# AKH Knitting & Dyeing Limited (Extension)

1 November 2023

**Observation-03:** Non-structural elements not anchored or braced. (Store & Dinning Building)

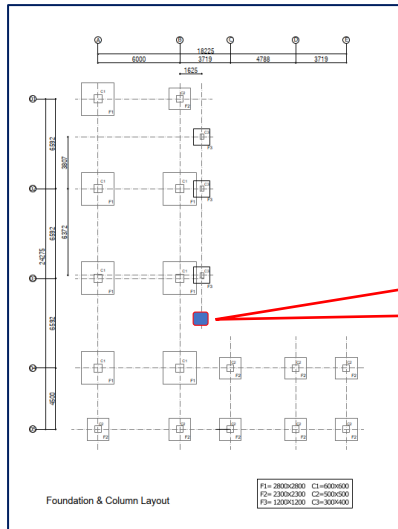
Racks on floor

Plastic water tank on roof

**Description:** Some racks on floors are not anchored and plastic water tank not braced to resist lateral (earthquake) forces. Building is required to anchor/brace all non-structural elements adequately to resist earthquake forces.

| Observation                                                                | Action Plan                                                                                                                                                                                                                       | Timeline        |
|----------------------------------------------------------------------------|-----------------------------------------------------------------------------------------------------------------------------------------------------------------------------------------------------------------------------------|-----------------|
| Non-structural elements not anchored or braced. (Store & Dinning Building) | Building is required to anchor/brace all non-structural elements adequately to resist earthquake forces.                                                                                                                          | within 6 months |
